ADDENDUM NO. 2

HCEB Continuing Education Office Remodel Floors 1 & 4

Brigham Young University  
Planning & Construction Dept.  
240 Brewster Physical Plant  
Provo, Utah 84602  
26 February 2024

**BRIGHAM YOUNG UNIVERSITY  
CONTINUING EDUCATION OFFICE REMODEL LEVELS 1&4  
Work Order No. N1864-N3482**

**N1864**  
**A2.0**

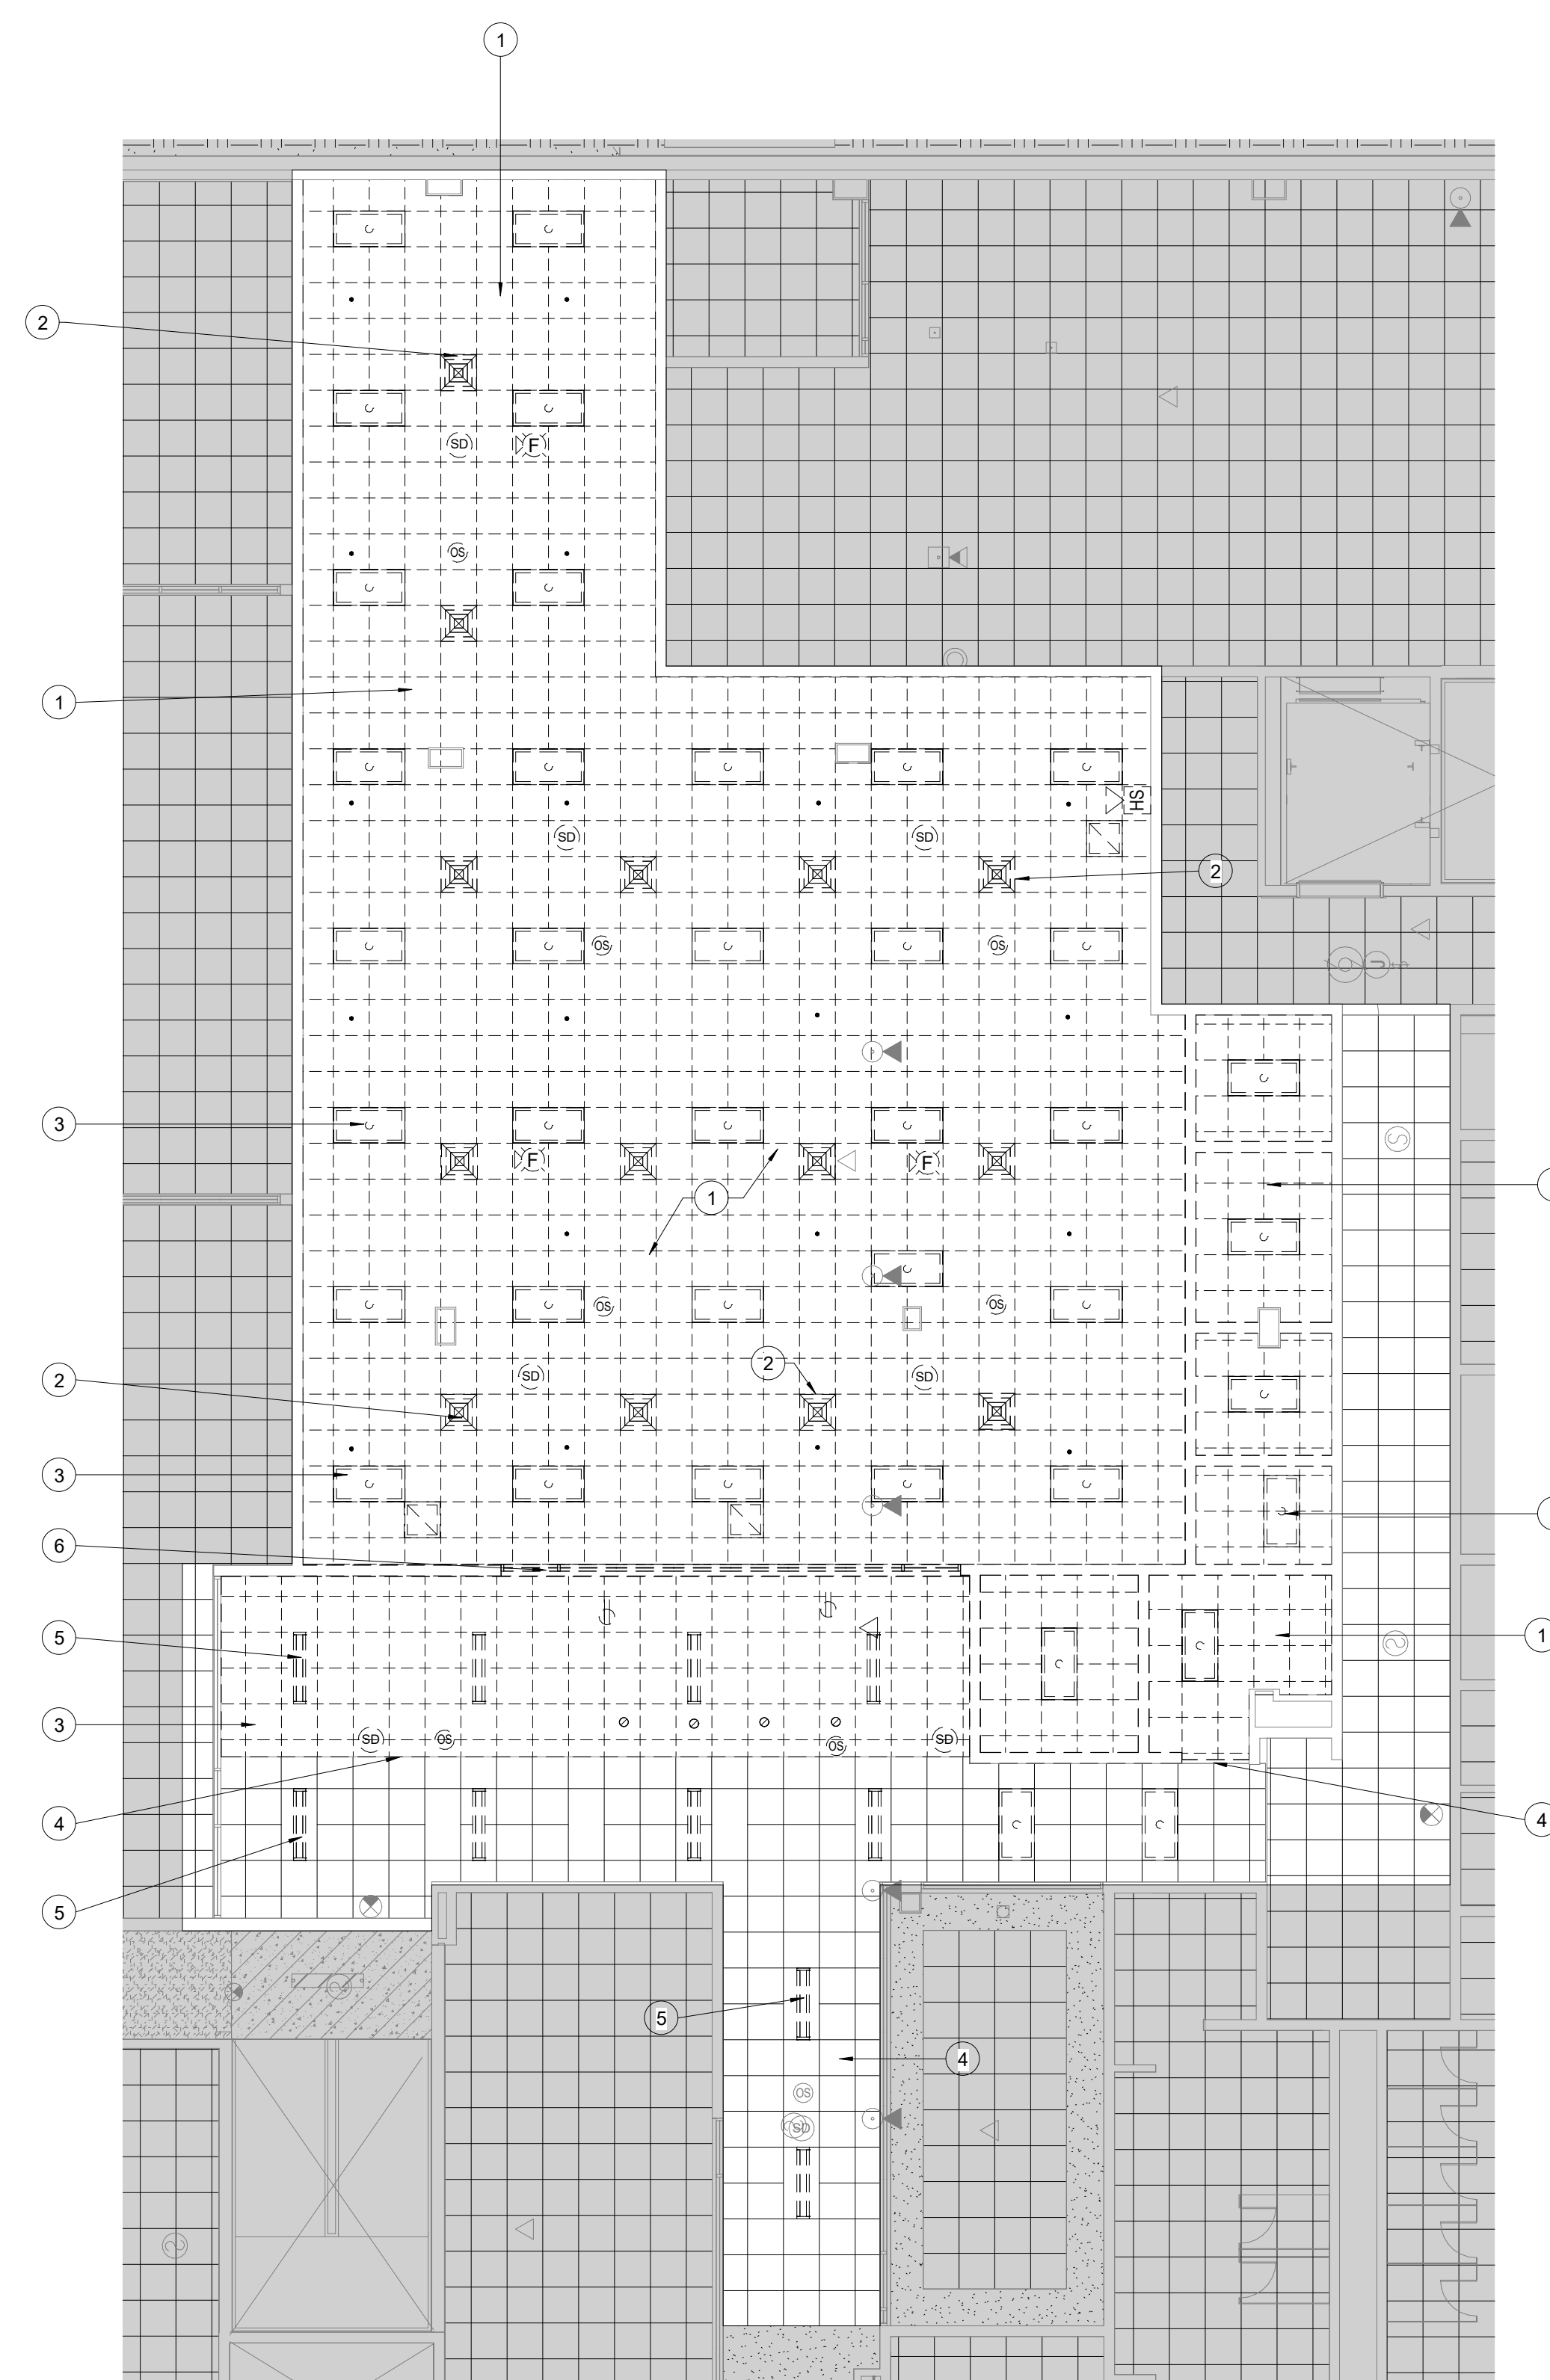
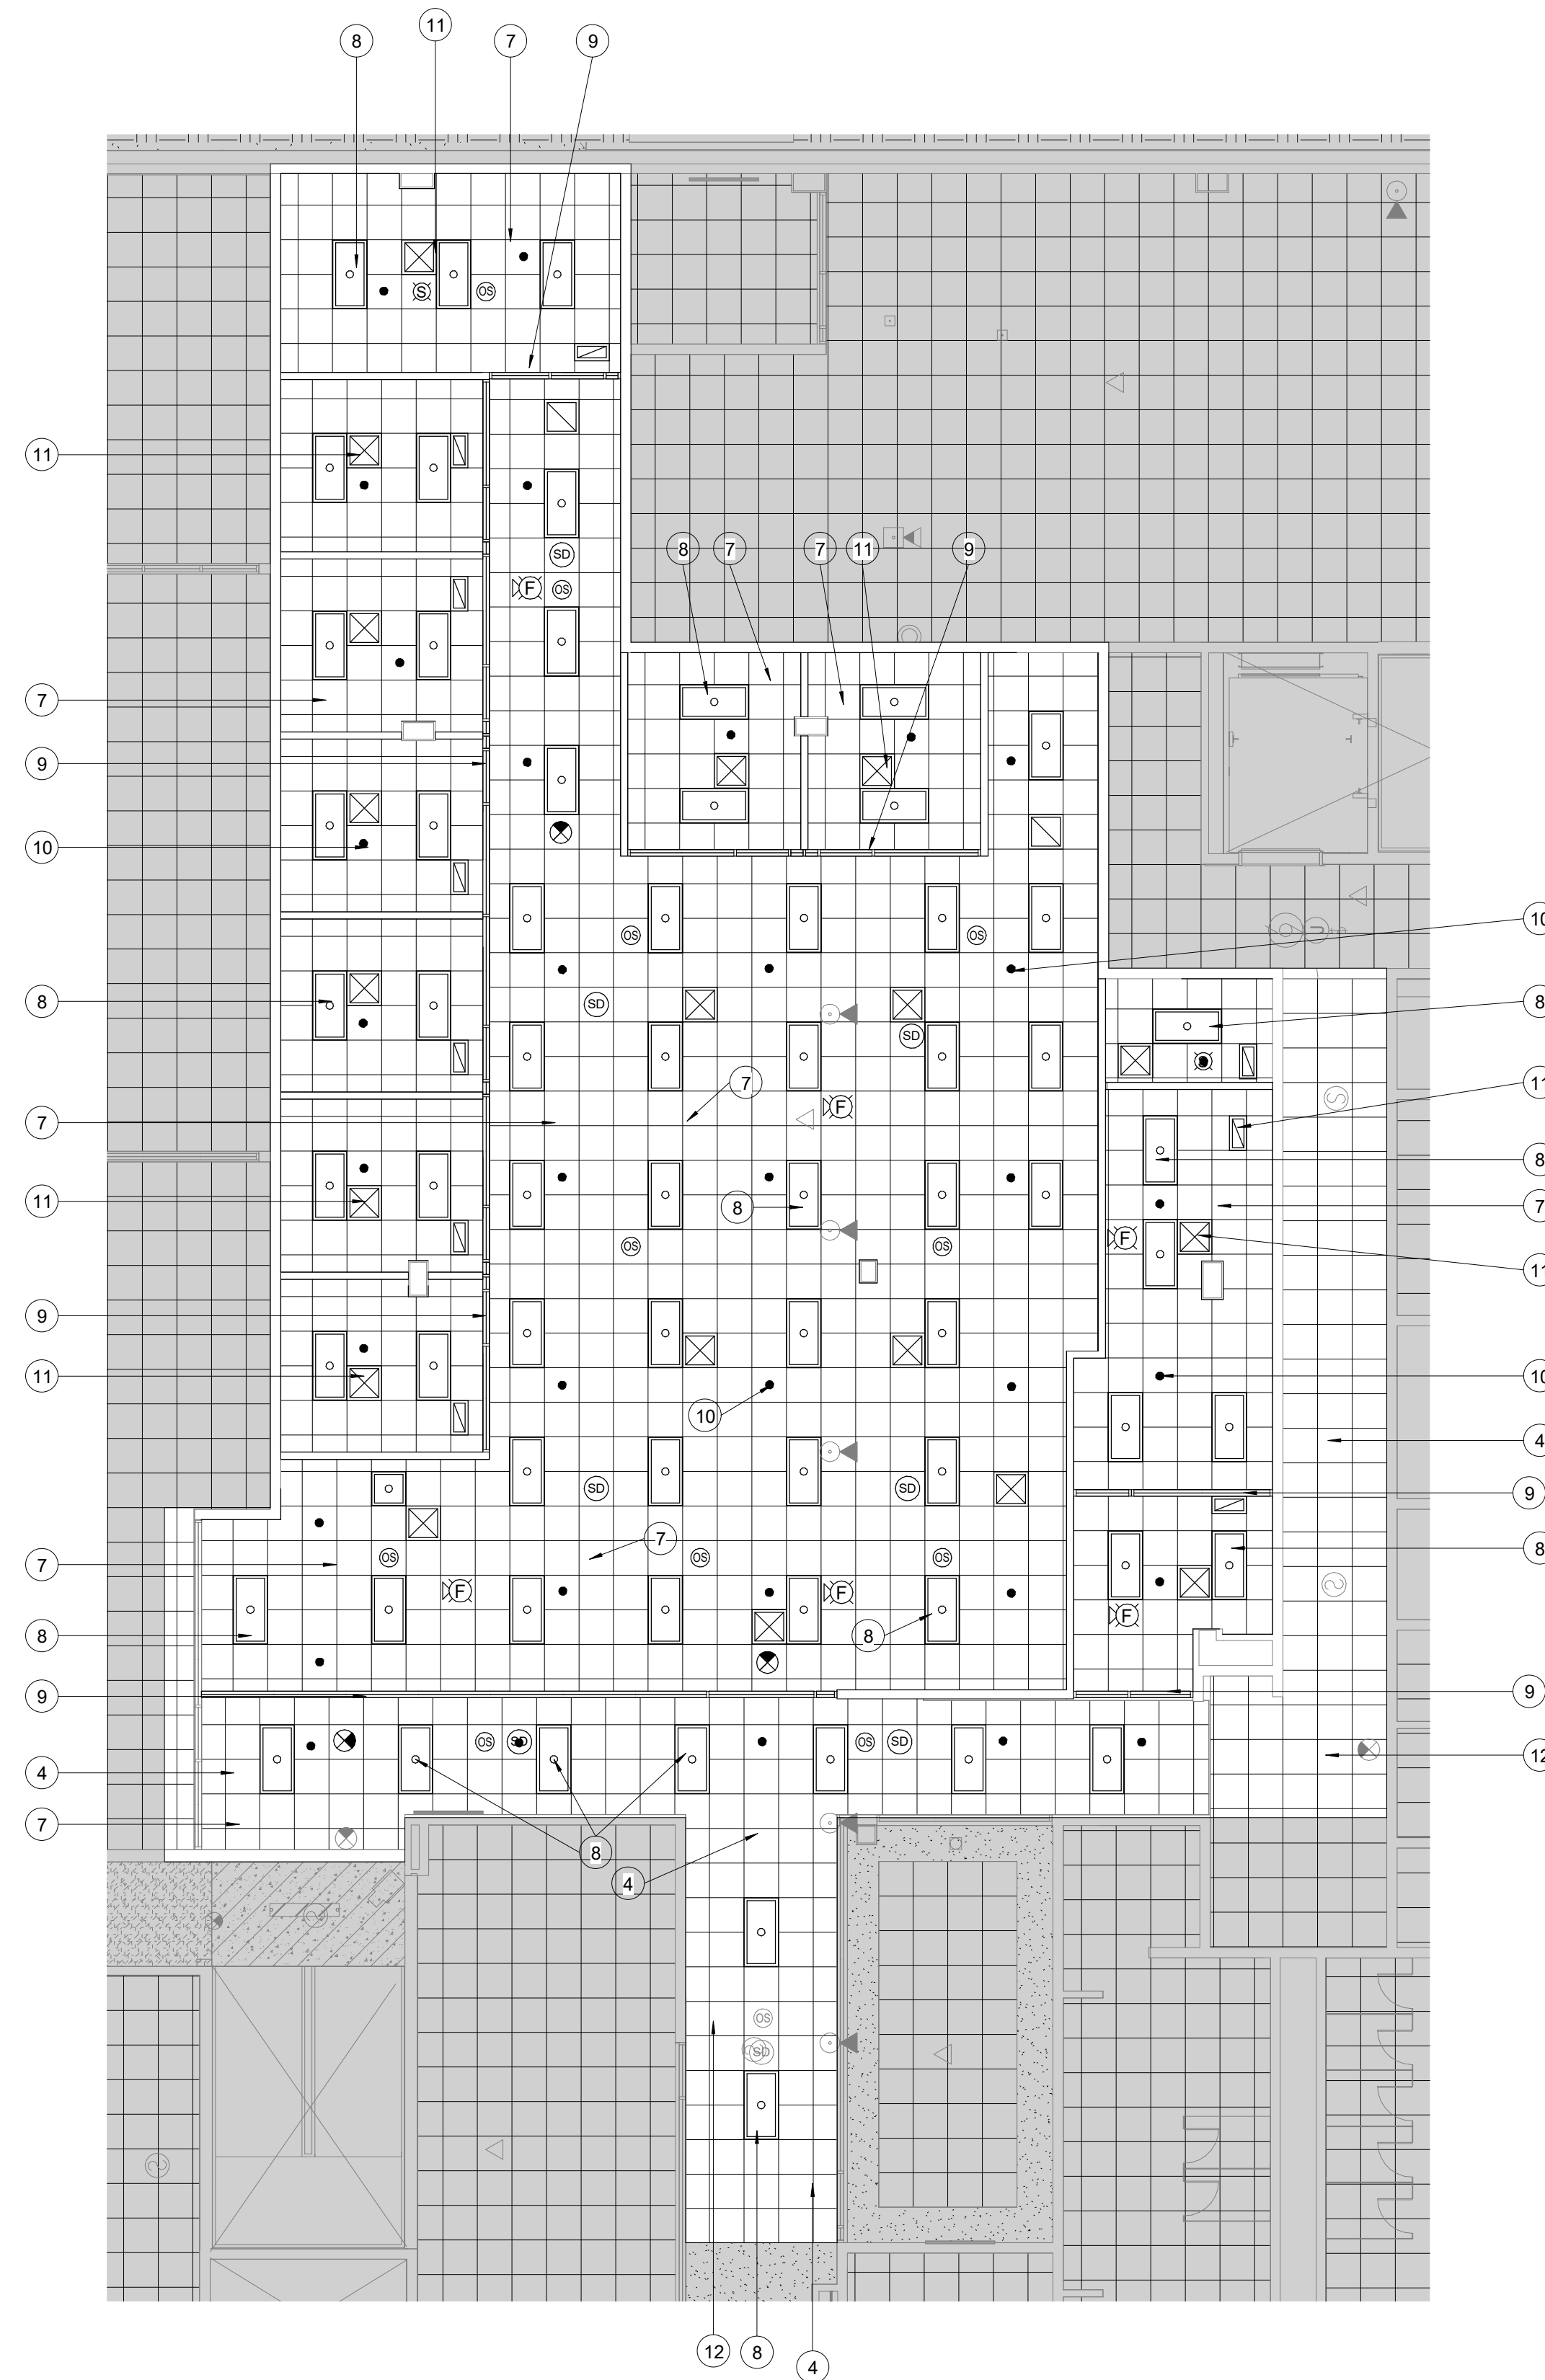
1. Sheet A2.0 N1864 (Level 1) See added notes for finished ceiling heights.
2. Sheet A4.0 N1864 (Level 1) See update sheet for hardware group 1 & 2.
3. Sheet A1.0 N3464 (Level 4) See added note for electrical panel location.
4. Sheet A1.0 N3482 (Level 4) note 7 refers to any modifications to the electrical and low voltage pathways noted on already issued electrical sheet. Use electrical sheets as the guide.
5. Sheet A2.0 N3482 (Level 4) See added notes for finished ceiling heights.
6. Sheet A3.0 N3482 (Level 4) Added Keynotes reference.
7. Sheet A4.0 N3482 (Level 4) See update sheet for hardware group 2.
8. Location of Electrical Panel Room notated on Sheet E1.0
9. USG Frost 490 is the only acceptable ceiling tile on this project.
10. There are no ACT-1, ACT-2, ACT-3 panels in this project, disregard in specs.

CEILING GRID - 9'-9"  
 TYPICAL FOR OPEN AREA AND OFFICES
